Access Compliance Report Public Rights-of-Way (Curb Ramps)

Main Street: SHEA_RIDGE Cross Street: ROLLING_RIDGE Location: W

ADA ID: RPRK211019143046 Ramp Type: Type 4 - Parallel Initial Pass/Fail: Fail Overall Compliance: No Severity Score: 30

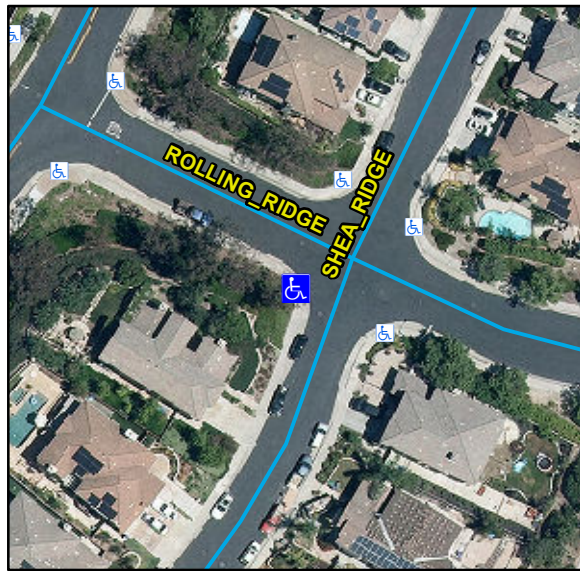
Compliance	Description	Data	Compliance	Description	Data
N/A	Ramp Length LT (in)	124	N/A	Ramp Length RT (in)	110
Yes	Ramp Width LT (in)	56	Yes	Ramp Width RT (in)	52
No	Ramp Run Slope LT (%)	13.5	Yes	Ramp Run Slope RT (%)	1.9
Yes	Ramp Cross Slope LT (%)	1.1	Yes	Ramp Cross Slope RT (%)	0.6
N/A	Landing Present	N/A	N/A	DWS Provided	N/A
N/A	Landing Length (in)	N/A	N/A	DWS Contrast	N/A
N/A	Landing Width (in)	N/A	N/A	DWS Length (in)	N/A
N/A	Landing Run Slope (%)	N/A	N/A	DWS Full Width	N/A
N/A	Landing Cross Slope (%)	N/A		DWS Offset Type	N/A
N/A	Landing Movement Obstructed?	N/A	N/A	DWS Offset Left (in)	N/A
	Landing Movement Type	N/A	N/A	DWS Offset Right (in)	N/A
N/A	Landing Shared	N/A			
N/A	Clear Space	Yes			
N/A	Clear Space To Crosswalk (in)	N/A			
N/A	Marked Crosswalk 1	No	N/A	Marked Crosswalk 2	No
	Crossing 1 Direction	NE		Crossing 2 Direction	SE
	Marked Crosswalk 1 Width (in)	N/A		Marked Crosswalk 2 Width (in)	N/A

Remove & Replace Curb Ramp With Two New Directional Ramps or Equivalent.

R304.3.2, STD 1115
